REVISED AGENDA - COMMITTEE OF THE WHOLE

*F.1 2002 Richmond Road, 1903, 1909 Birch Street, and 1769 Pembroke Street:
Rezoning Application No. 00862 and Development Permit with Variances
Application No. 00252 (Jubilee)

A report regarding a Rezoning Application and Development Permit with Variances Application to rezone and consolidate the properties at 2002 Richmond Road, 1903/1909 Birch Street and 1769 Pembroke Street to increase the density and construct a six-storey rental residential building with commercial uses at grade, a rooftop amenity space, and a surface parking lot, and recommending that the application proceed to bylaw readings.

Figure 3: Option B – Plaza

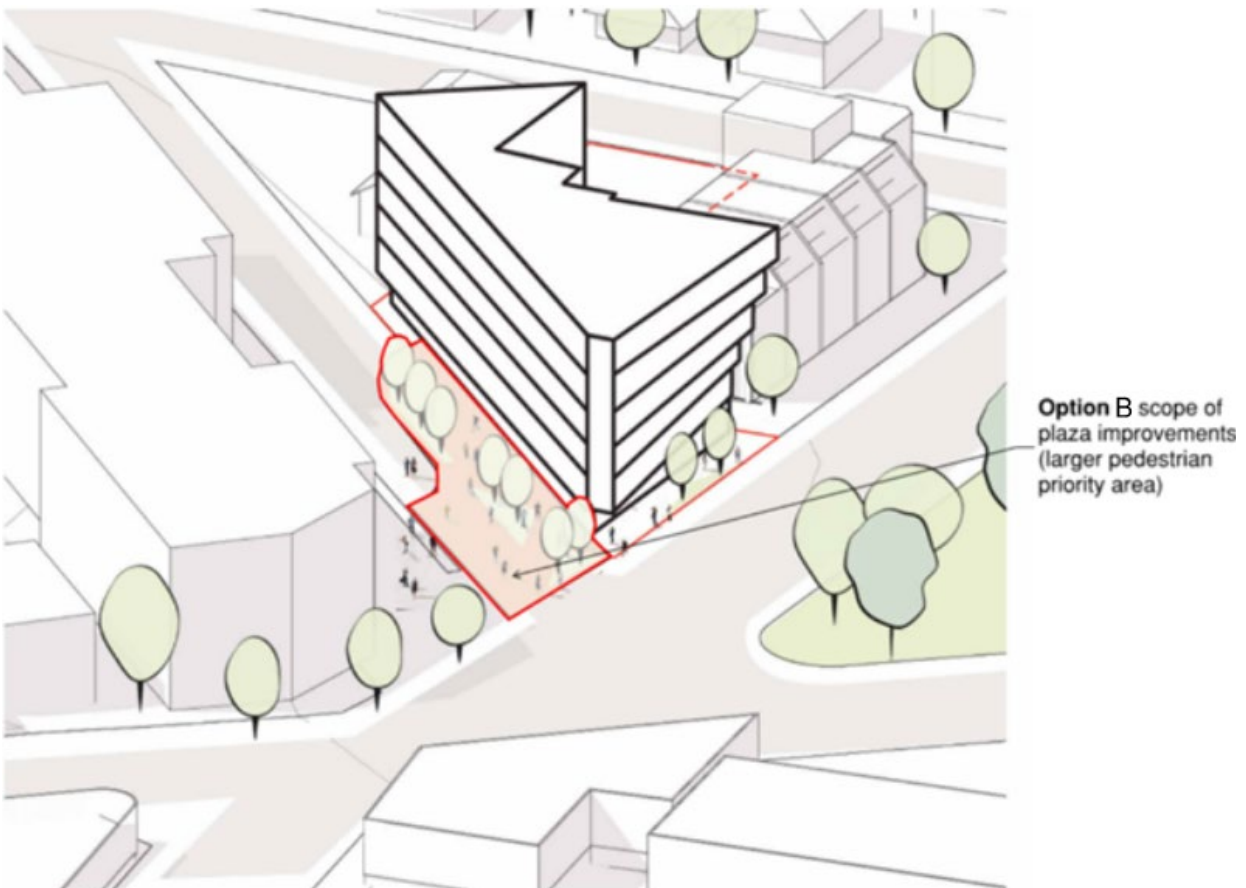
improvements. Option A is not recommended as it does not leverage an opportunity to achieve an improved public realm in support of OCP goals and objectives.

- Option B – Full Plaza (recommended): Birch Street frontage works are built in partnership with the City. Plaza improvements would extend beyond centreline and tie into the existing curb on the south side of Birch Street. Plaza improvements would be designed and constructed by the applicant to the satisfaction of the Director of Engineering, with funding provided by the City. Construction of the plaza would require the closure of that portion of Birch Street, as identified in plans dated May 2, 2024, to all traffic except emergency vehicle, bicycle, and pedestrian access.
